**DEQ Coal Combustion Residuals
Surface Impoundment
Closure Determination**

Marshall Steam Station

April 1, 2019

Figure ES-1: Marshall Steam Station January 2018 CSA Update Report

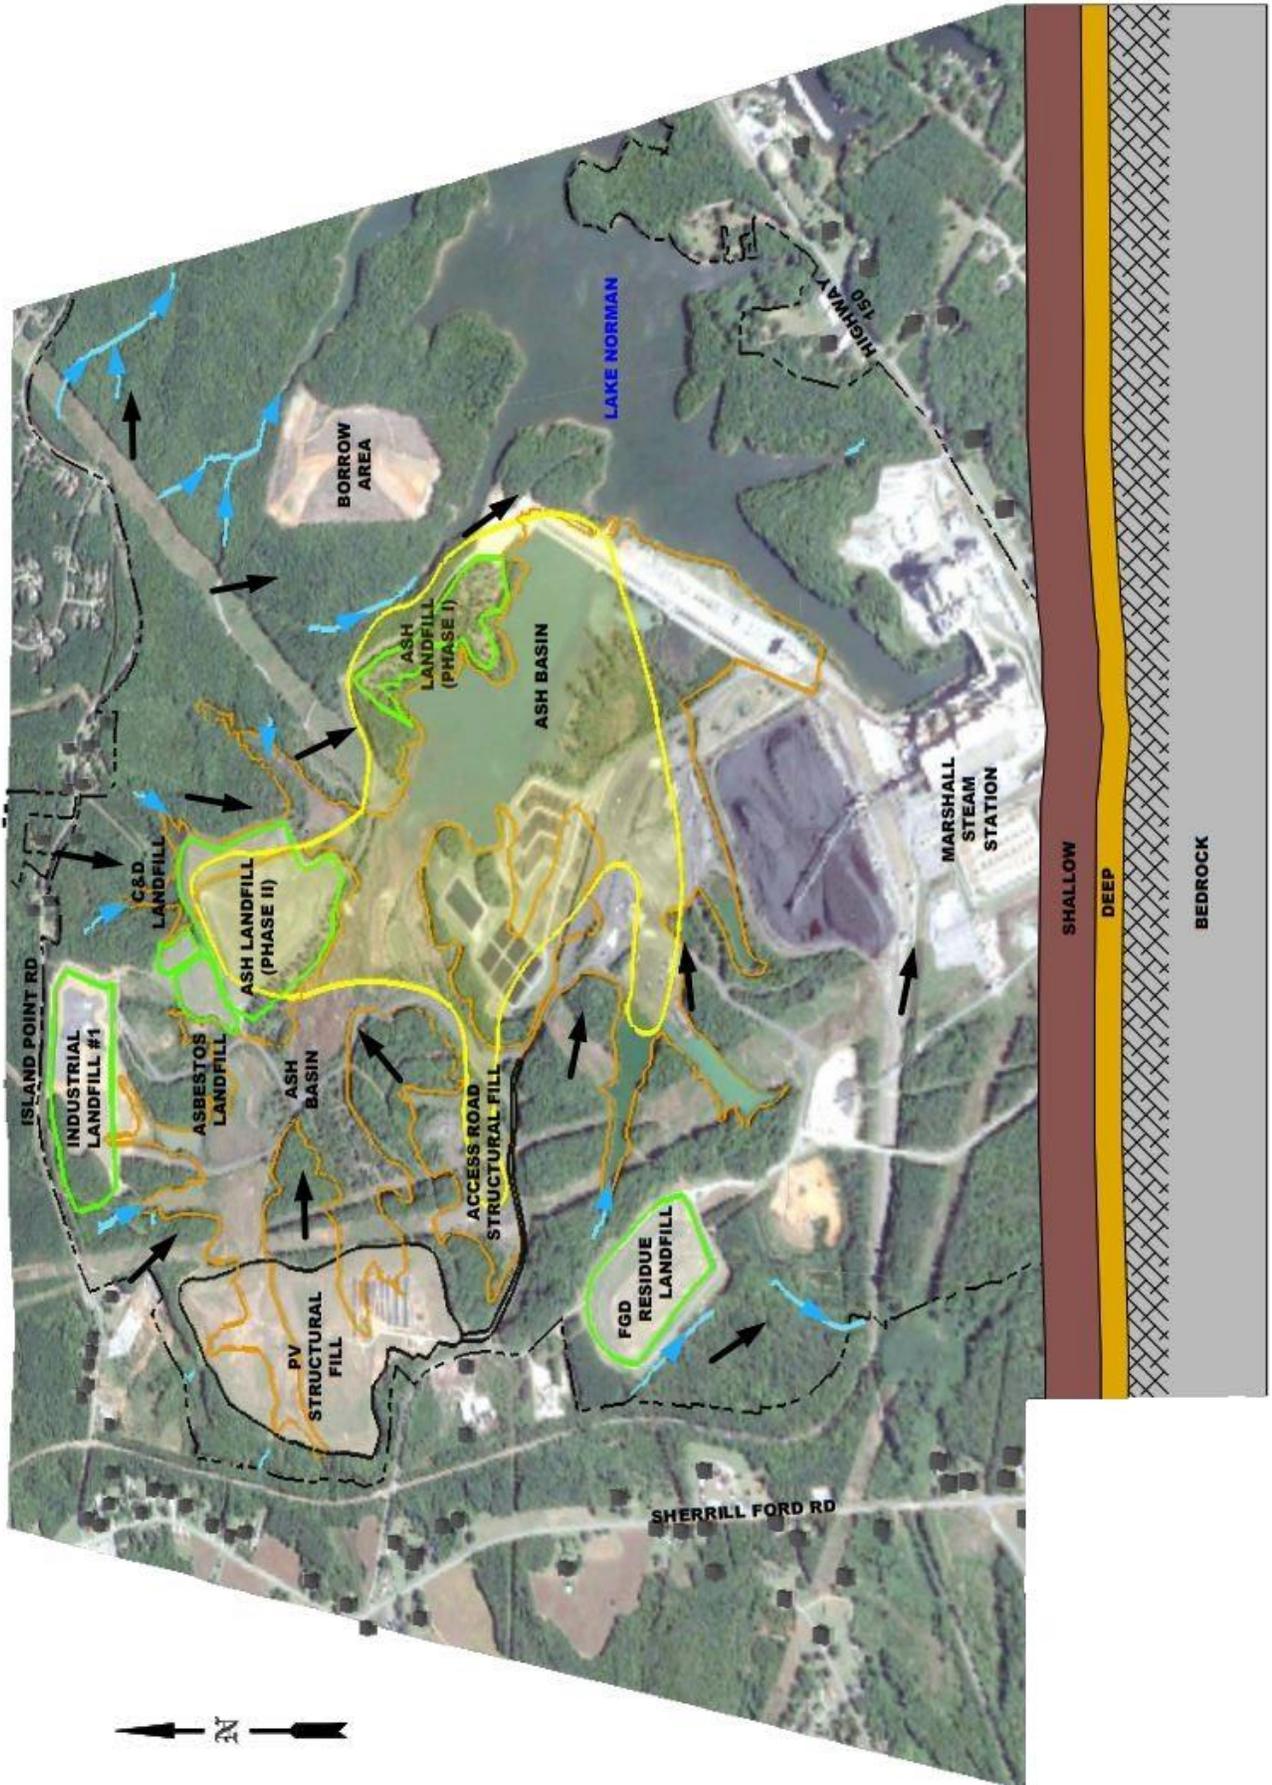
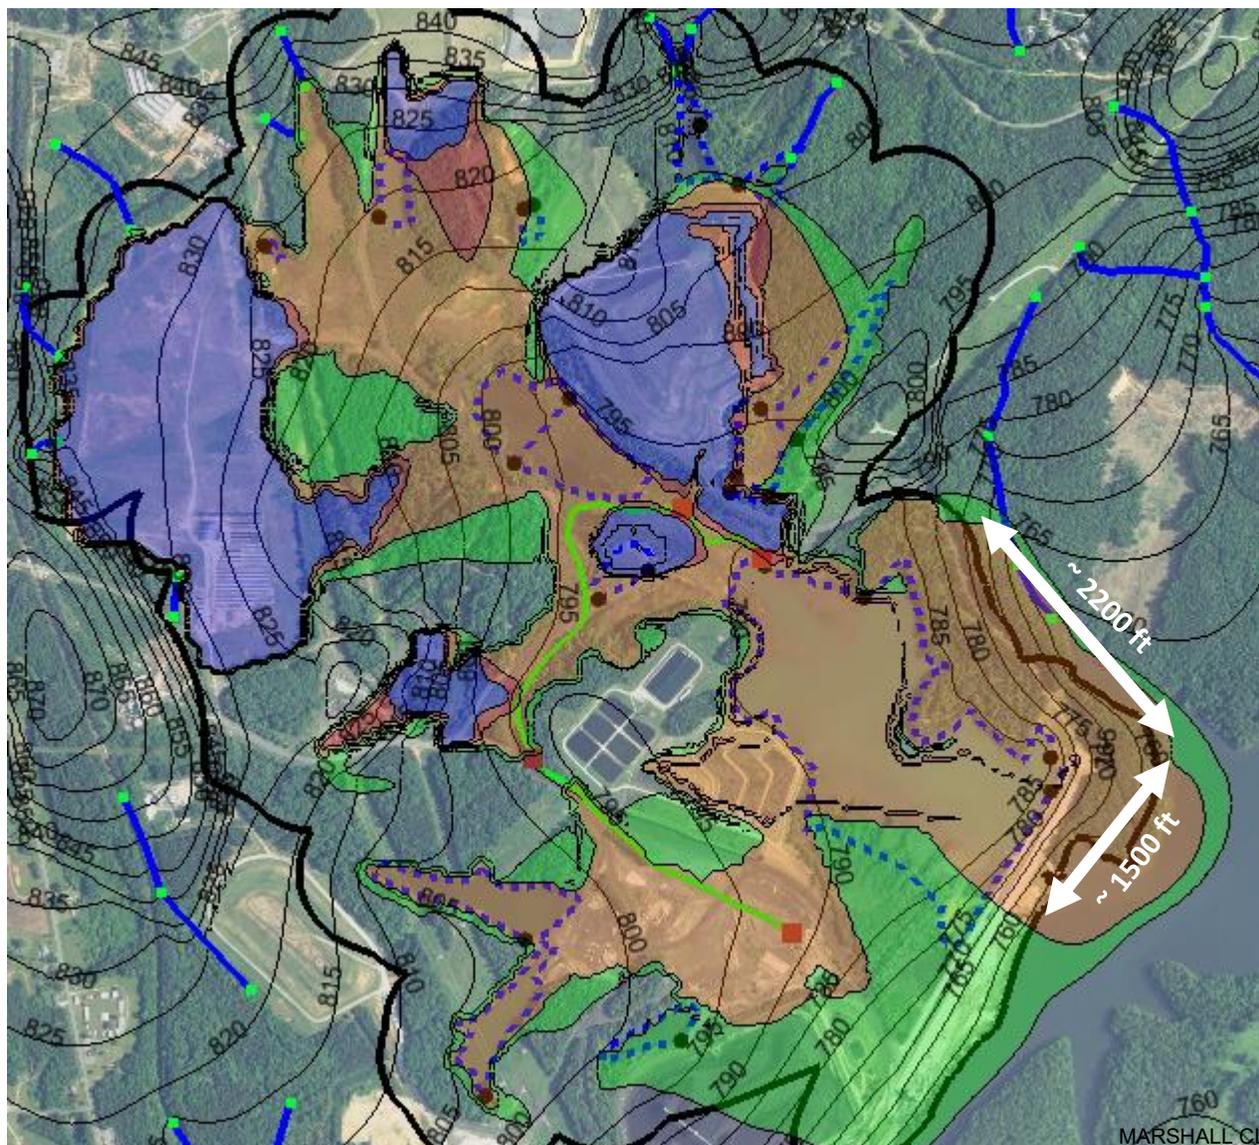
The groundwater site assessment at the Marshall Steam Station, as required by CAMA, began in 2015 and is still on-going. Based on review of data submitted to date in various reports, both soil and groundwater has been impacted by CCR handling activities at the site. Groundwater within the area of the CCR surface impoundment generally flows from northwest to southeast and discharges to Lake Norman as depicted on Figure ES-1 (below). The inferred general extent of groundwater impacts above applicable PBTVs or 2L Standards are shown on Figure ES-1 from the January 2018 CSA Update Report below. Boron concentrations above 2L Standards approximates the leading edge of the CCR plume (area shaded yellow) at the site.

The vertical extent of most COIs is within the shallow and transition flow layers. However, data suggests the bedrock flow layer has been impacted by CCR handling activities at the site. Manganese and strontium concentrations are fairly widespread in the bedrock flow layer. There are isolated occurrences of boron, chloride, iron, molybdenum and TDS within and downgradient of the ash basin.

DEQ concludes that the contaminated groundwater plume above 2L groundwater standards has extended beyond the compliance boundary along the northern and eastern edge on the shore of Lake Norman.
